# Access Compliance Report

## Public Rights-of-Way

Intersection ID: 46324	Main Street: ARBOR_VISTA_DR	Cross Street: SENATOR_ROYALL_DR	Location: SE
ADA ID: 303745784F80	Ramp Type: PerpDiag	Initial Pass/Fail: Fail	Overall Compliance: No
Severity Score: 10			
Codes/Mitigation Info/Possible Solution		Field Measurements/Component Compliance

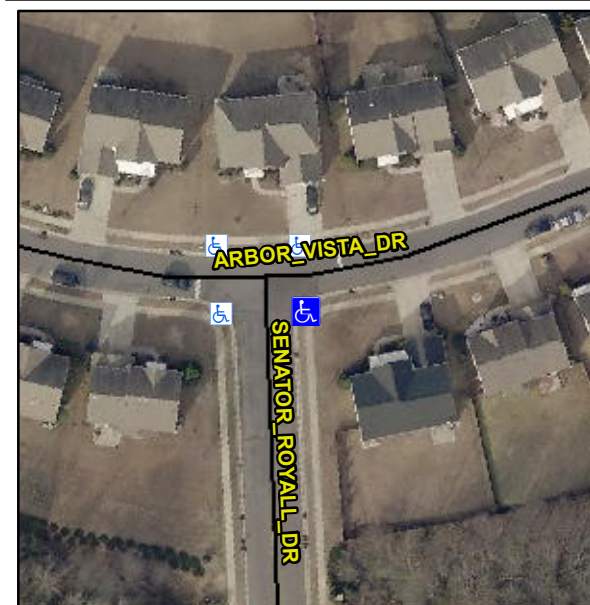
**Not Found, R304.5.1, R304.5.3**

Compliance	Description	Data	Compliance	Description	Data
N/A	Ramp Length (in)	49.0	Yes	Ramp Slope (%)	7.1
No	Ramp Width (in)	41.0	No	Ramp XSlope (%)	4.6
N/A	Flare Type LT	N/A	N/A	Flare Type RT	N/A
N/A	Flare Slope LT (%)	N/A	N/A	Flare Slope RT (%)	N/A
N/A	Flare Traversable LT?	N/A	N/A	Flare Traversable RT?	N/A
N/A	Landing Length (in)	N/A	N/A	DWS Provided?	N/A
N/A	Landing Width (in)	N/A	N/A	DWS Contrast?	N/A
N/A	Landing Slope (%)	N/A	N/A	DWS Length (in)	N/A
N/A	Landing X Slope (%)	N/A	N/A	DWS Full Width?	N/A
N/A	Landing Curb? (Y/N)	N/A	N/A	DWS Offset (in)	N/A
N/A	Shared Landing?	N/A			
N/A	Gutter Ponding?	N/A	N/A	Gutter Slope (%)	N/A
N/A	Gutter Lip Ht (in)	N/A	N/A	Gutter X Slope (%)	N/A
N/A	Painted X Walk1?	No	N/A	Painted X Walk2?	No
	X Walk 1 Direction	To N		X Walk 2 Direction	To W
N/A	X Walk 1 Width (in)	N/A	N/A	X Walk 2 Width (in)	N/A
	X Walk 1 Slope (%)	8.8		X Walk 2 Slope (%)	2.1
	X Walk 1 X Slope (%)	3.2		X Walk 2 X Slope (%)	4.2

**Remove & Replace Curb Ramp With Two New Directional Ramps or Equivalent.**
